ZONING BOARD OF APPEALS APPLICATION

AREA VARIANCE

Street Address: 225 Monsell Place, Greenport, NY 11944 Greenport, New York, 11944

NOTICE OF DISAPPROVAL

2 SITE PLAN
 1/8" = 1'-0"

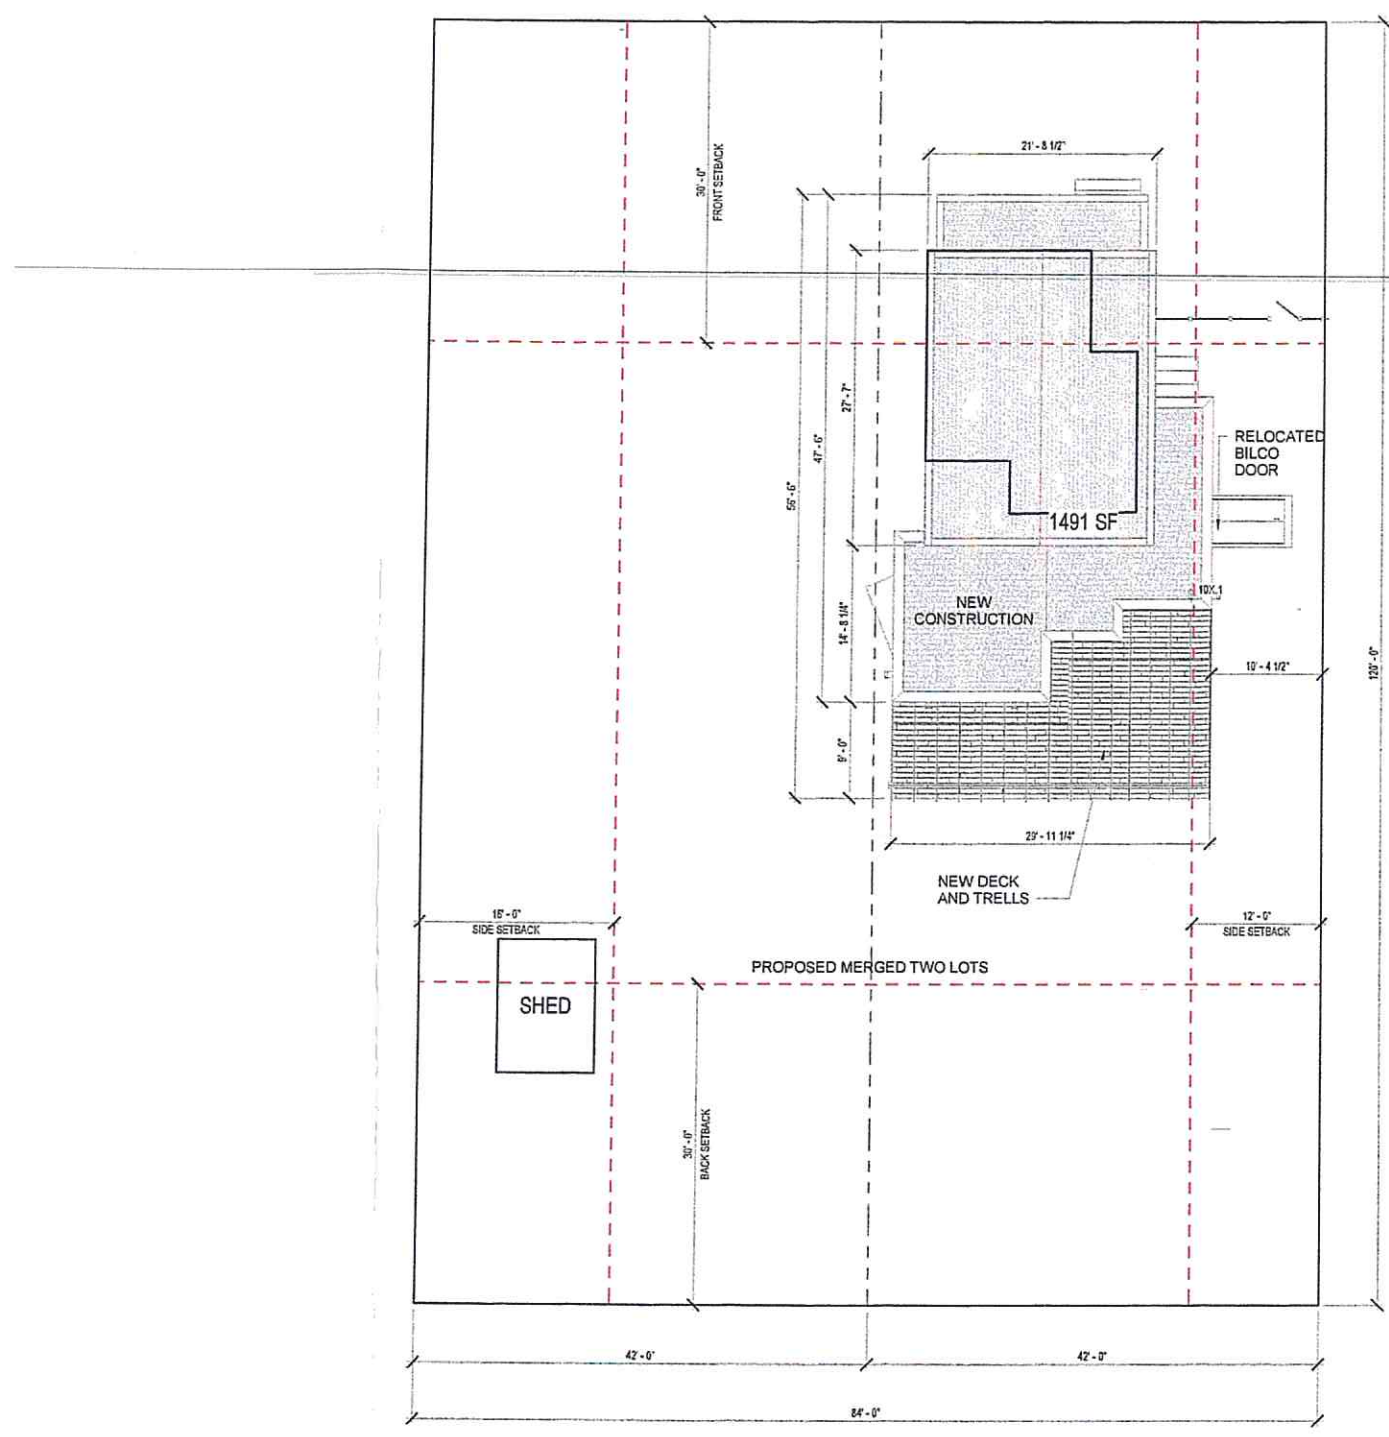
The plans show the merger of 2 nonconforming lots. The code prohibits the combining or merging two or more of those lots This would require an area variance.

The plans show the rear yard of the setback of 17 feet.

This would require an area variance 13 feet

The plans show a side yard setback of 7 feet

This would require an area variance of 3 feet.
